TO: Buck Oven
 FROM: Clair Fancy 
 DATE: February 25, 1993
 SUBJ: OUC's Stanton #2: Concrete Batch Plant Evaluation for a PPS Certification Modification Request

Re: Orlando Utilities Commission's Proposed
Modification of Site Certification to
Authorize Construction of a Temporary Concrete
Batch Plant; Curtis H. Stanton Power Plant,
Unit No. 1 - PA-81-14

Re: Orlando Utilities Commission Request for Modification of
Conditions Of Certification for Stanton Energy Center

PROPOSED AGREEMENT FOR
MODIFICATION OF CERTIFICATION

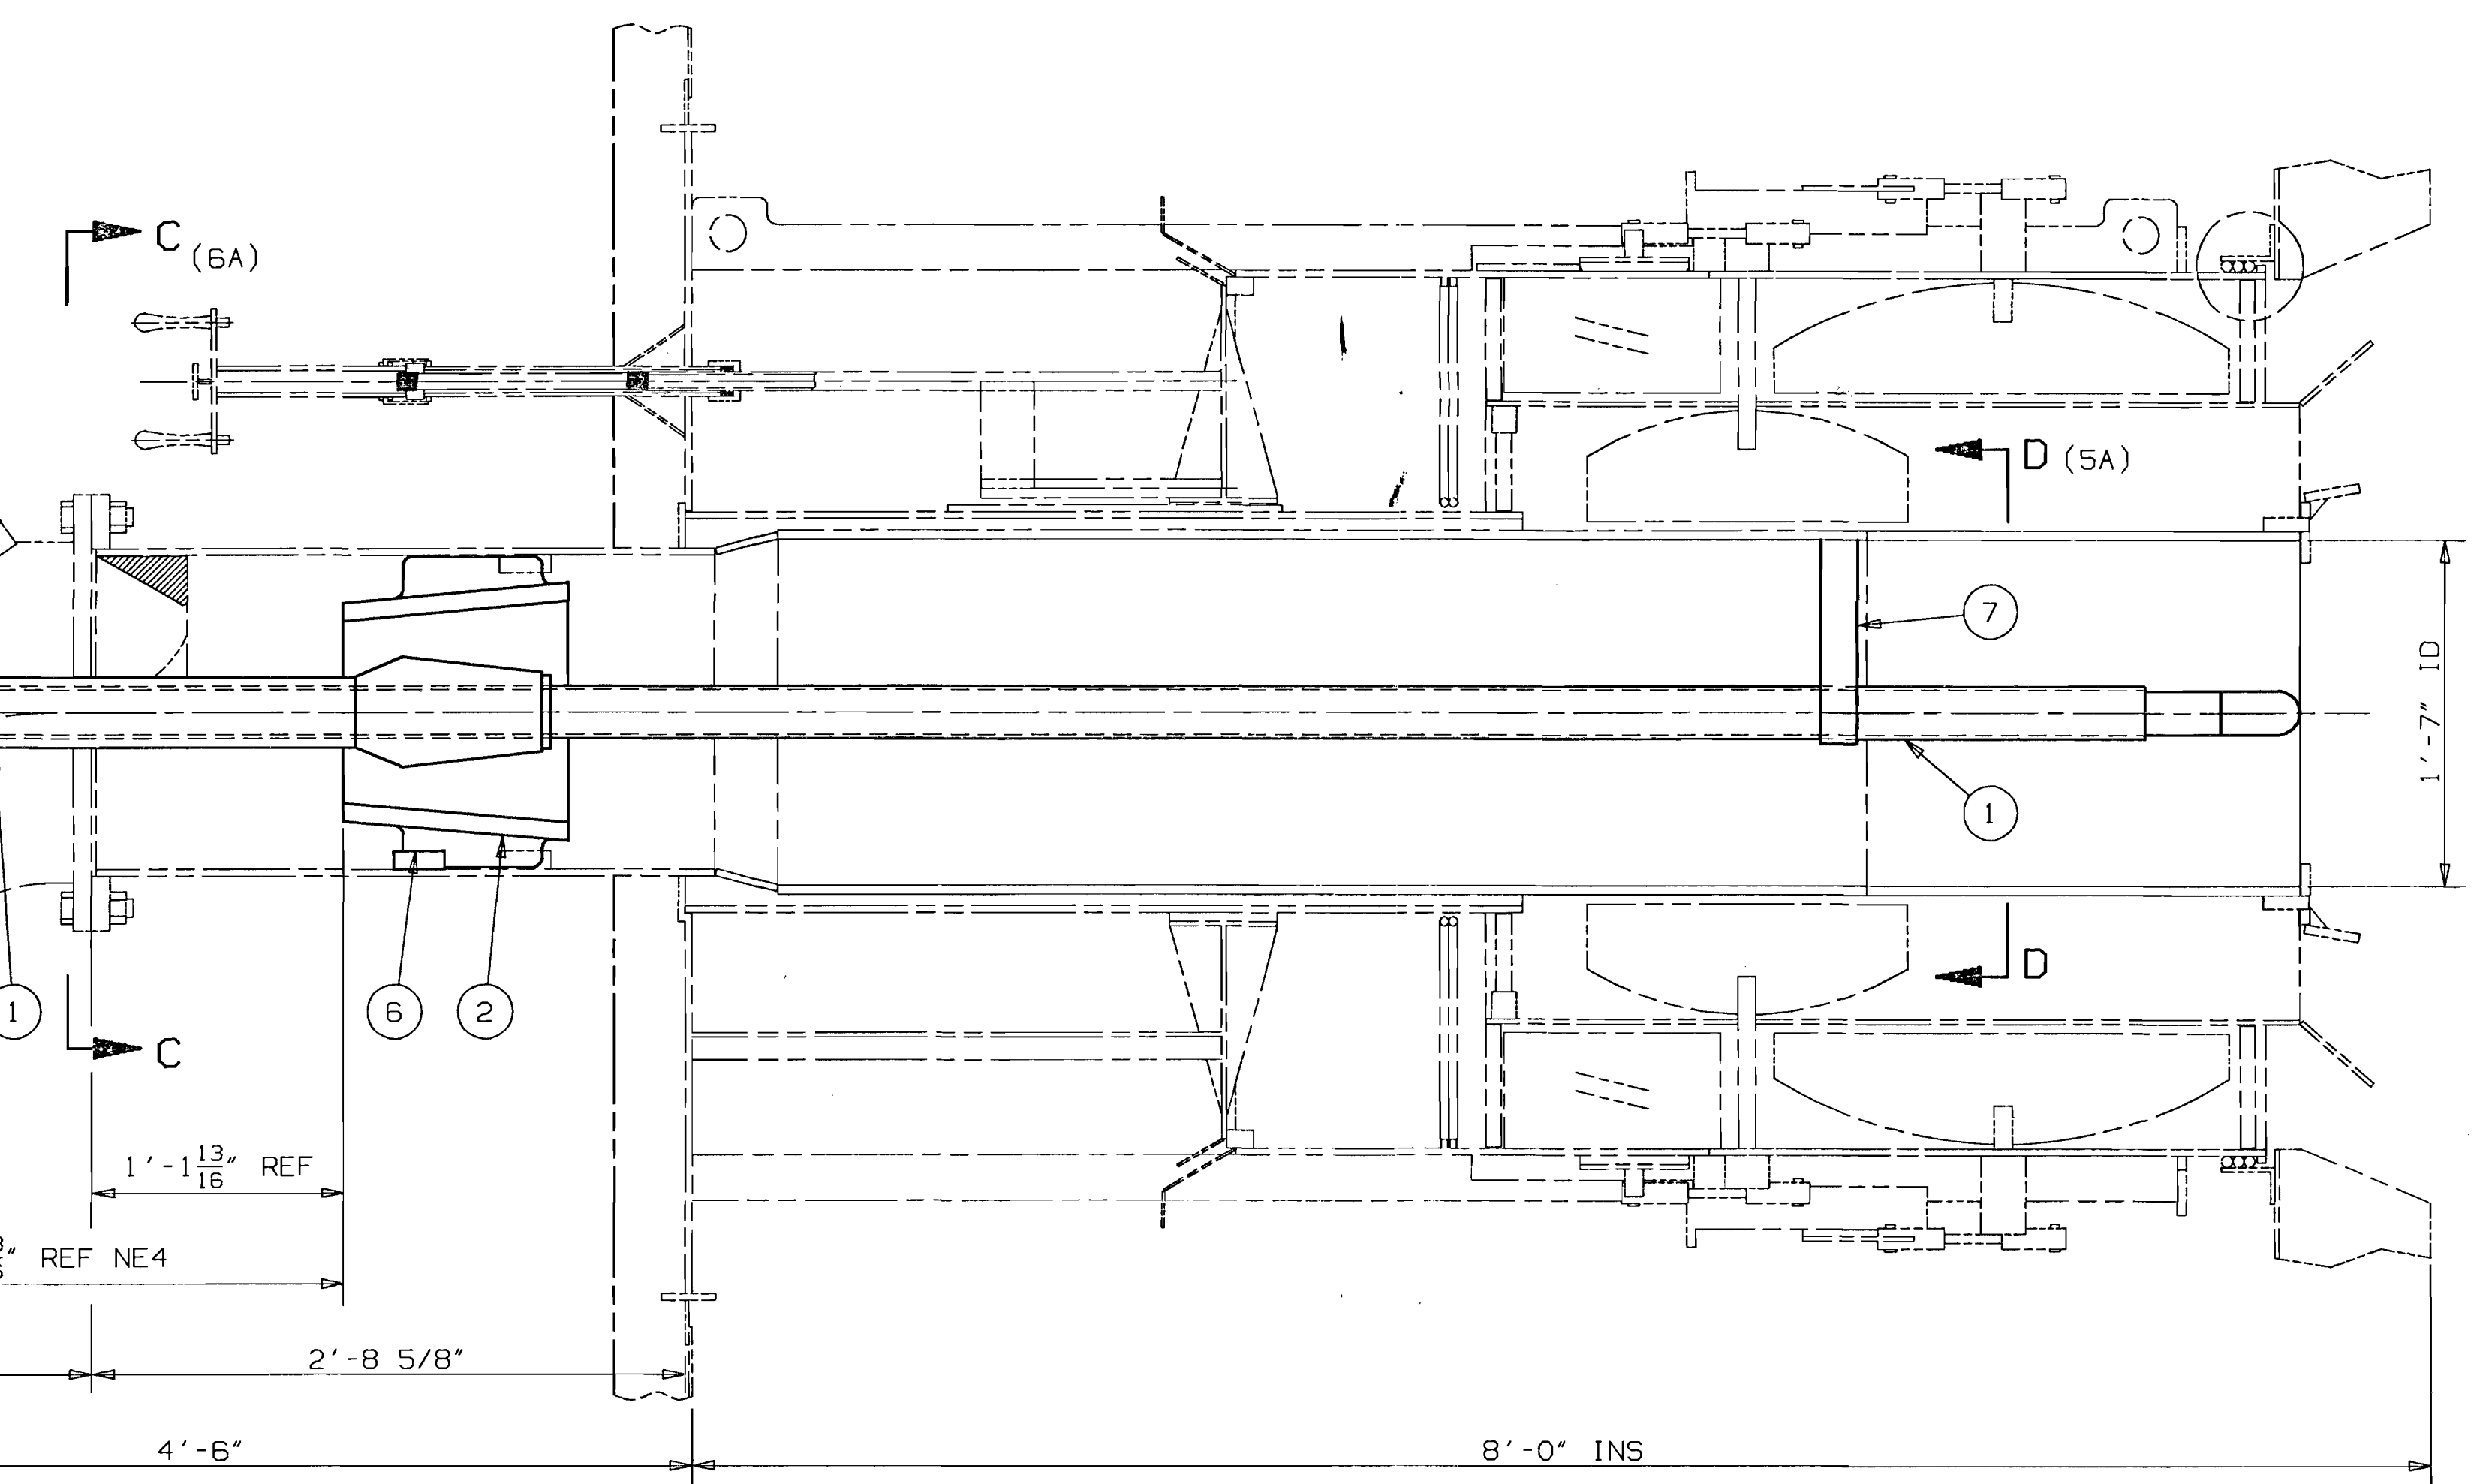
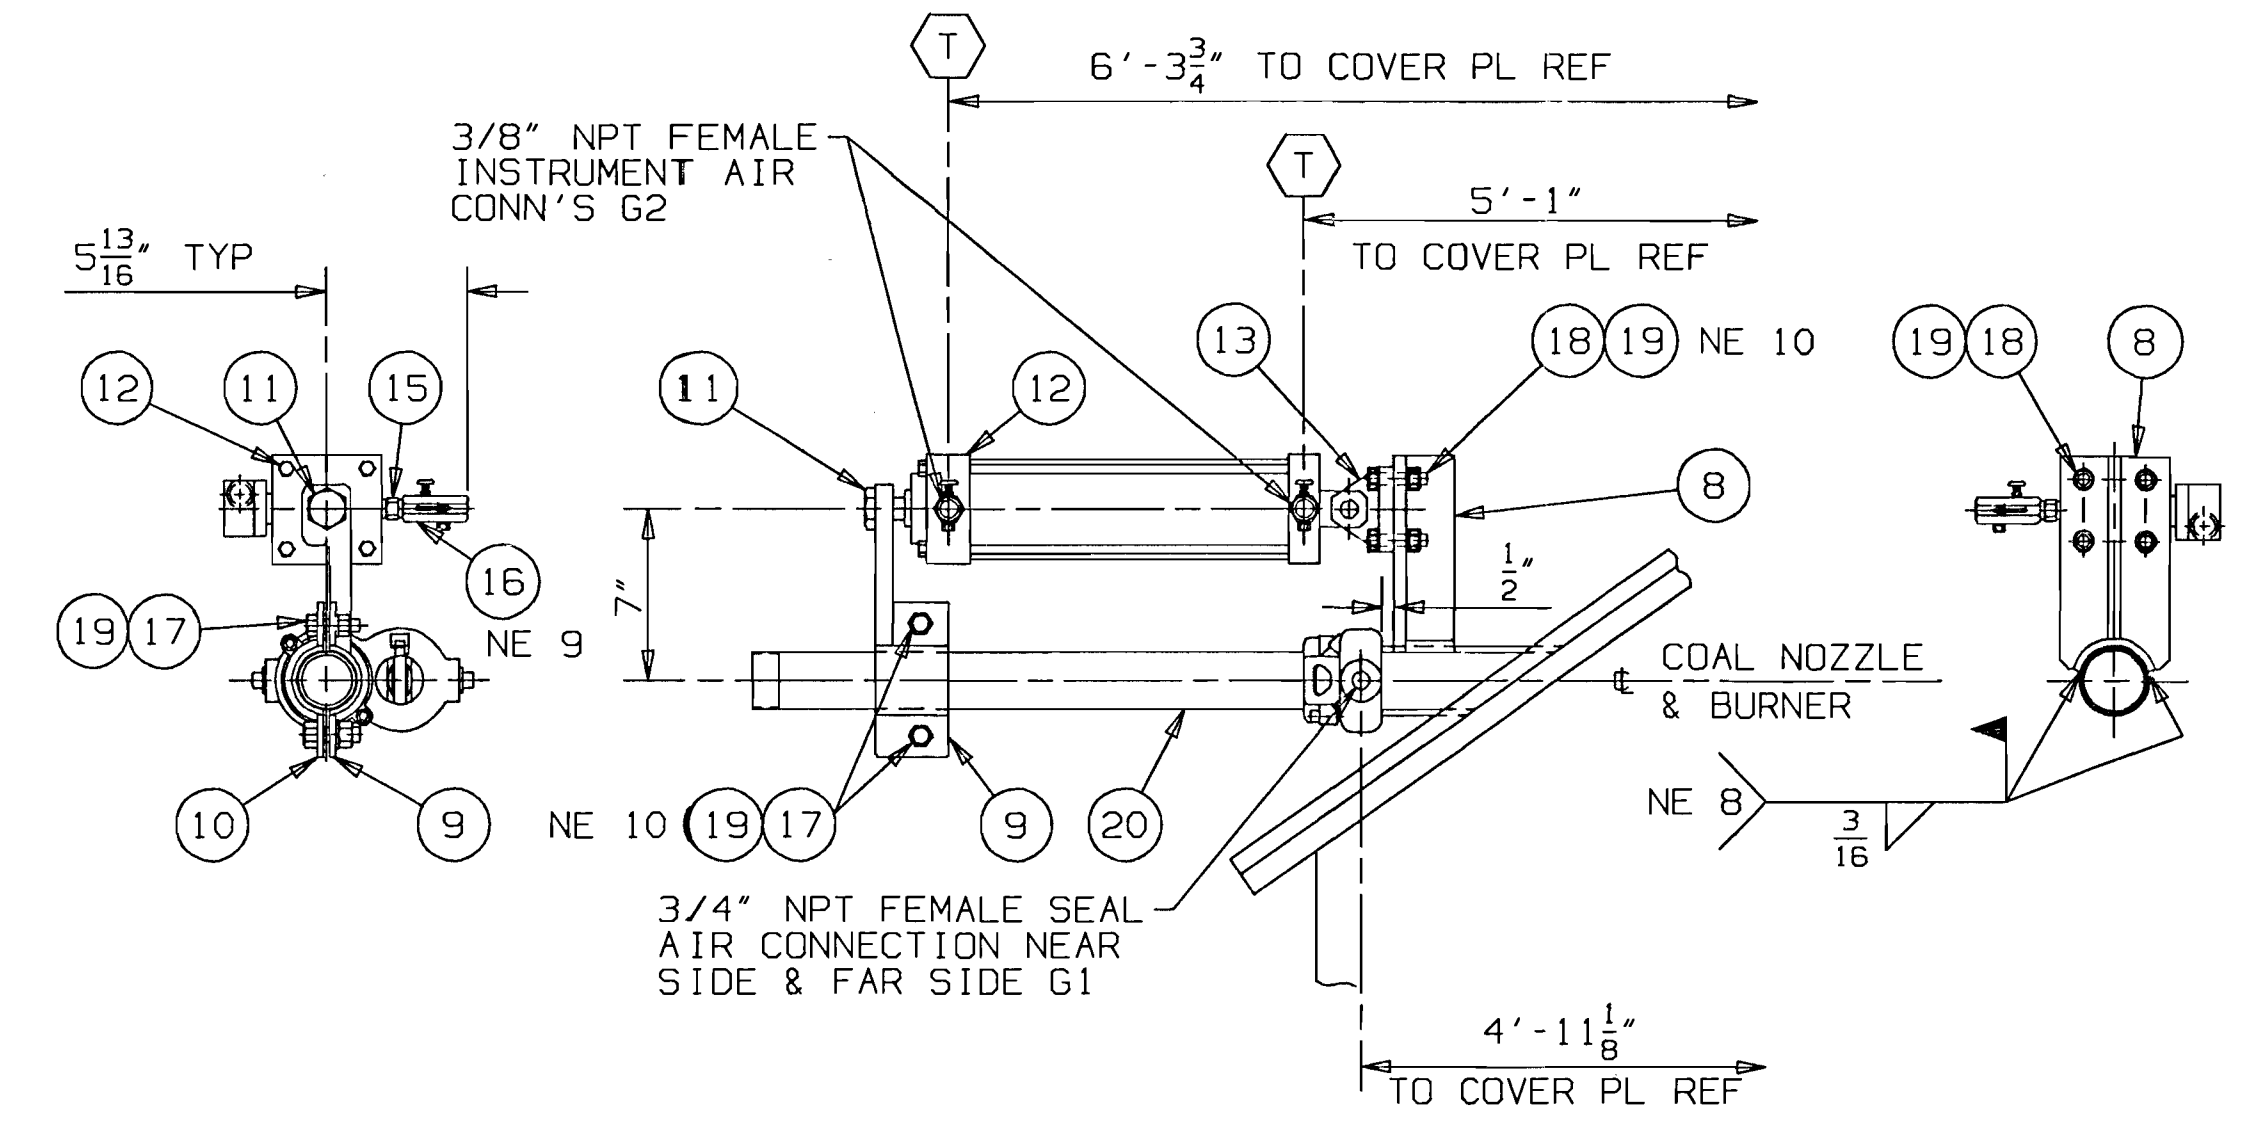
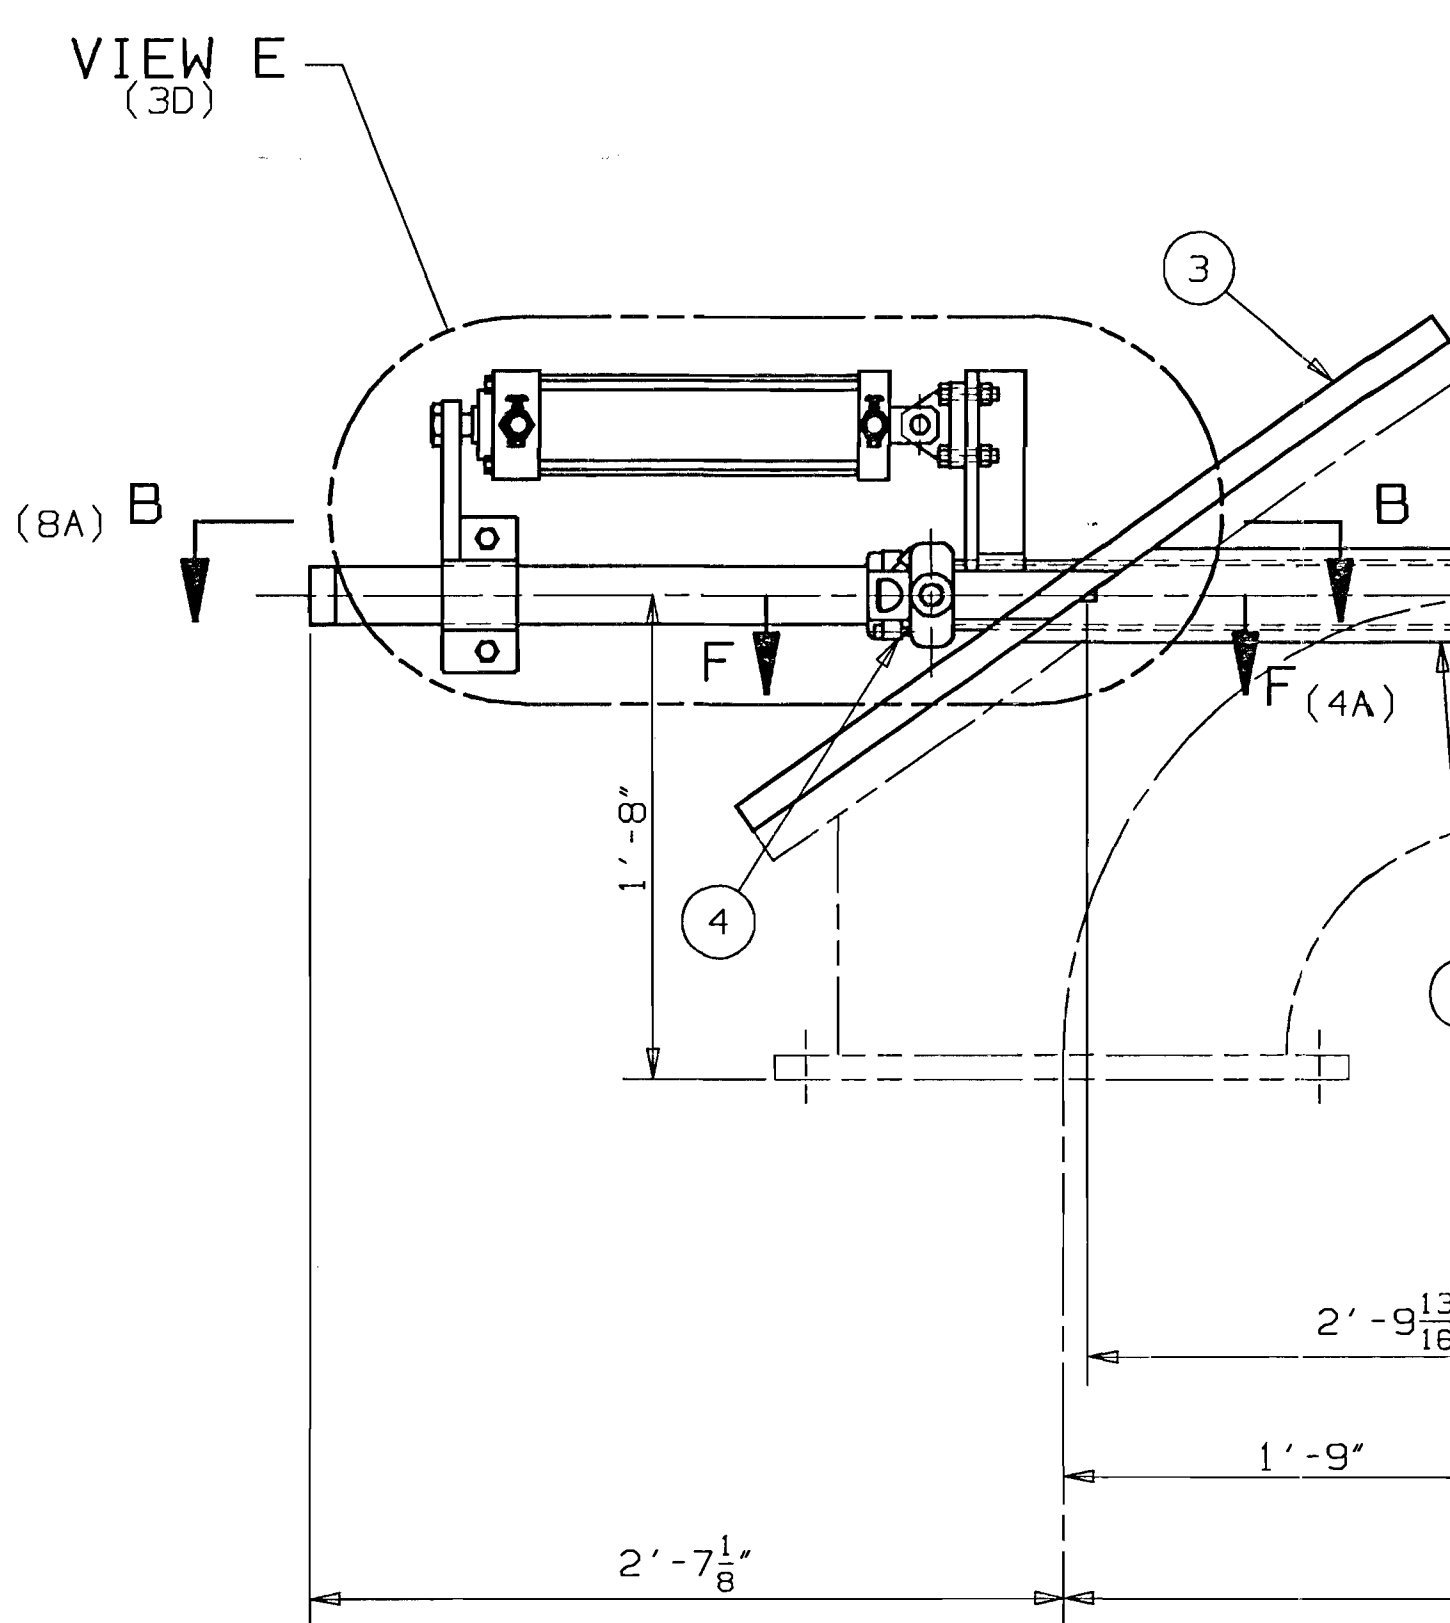
Exhibit 4, Babcock & Wilcox Drawing No. 522900E (Field Alteration DRB-XCL Burner).

REVISIONS			
REV	DESCRIPTION	DATE	APPROVAL
1	RELOCATED VIEW B-B, SECT C-C & SECT D-D, ADDED VIEW E, SECT F-F, NOTES NE7, NE8, NE9, NE10, G1, G2, G3 AND FIND NO. 8 THRU 21.	3/28/97	LLW
